SERVICE BULLETIN

Communication #: L-21-01

SUBJECT: FAST CHARGER WIRE HARNESS

2016-2021 GEM E2, E4, E6, EL XD BUILT WITH FAST CHARGER (3 KW OR 6 KW)	
Bulletin #	L-21-01
Claim Type	SB (Service Bulletin)
Labor Allowance	0.8 hours (48 minutes)
Part Number / Description	2416229 (QTY 1) HARNESS-CHARGER,FAST,MAIN,FSD 7080492 (QTY 7) CABLE TIE, 11 IN
Parts Availability	Available to order
University of Polaris Video Training Required	NO

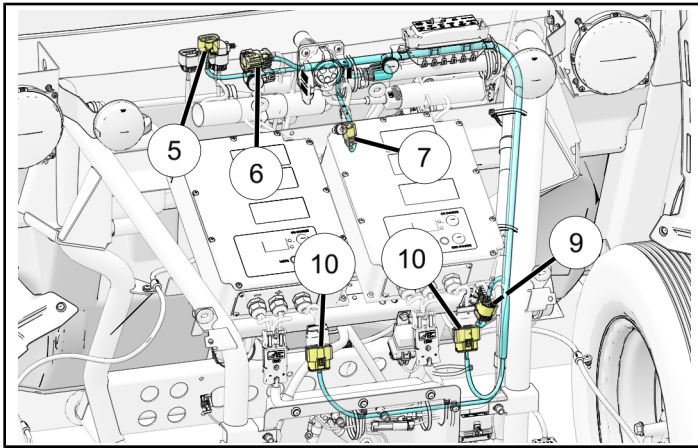
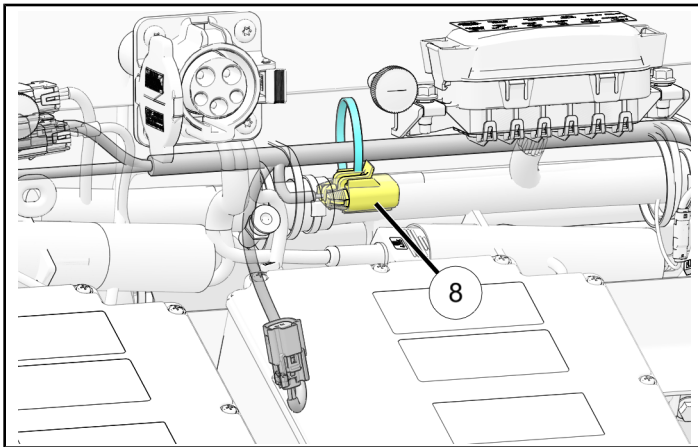
Some 2016-2021 GEM vehicles built with Fast Chargers (3 kW or 6 kW) may experience a premature failure to the charger itself, if a short circuit occurs on the vehicle.

To address this concern, GEM is releasing this Service Bulletin for dealers to replace the fast charger harness in all affected vehicles with a new harness that has a built-in fuse holder. Please refer to the instructions within this Bulletin.

1. Install the *NEW* Fast Charger harness by connecting the diagnostic connectors ⑤ and ⑥, the charge port connector ⑦, the standard connector ⑨, and the 16-pin connectors ⑩.

2. Secure the harness with the new cable ties in the previously noted locations. Retain the new inline fuse holder ⑧ by looping a cable tie through its mounting hole and securing it to the fast charger harness, itself.
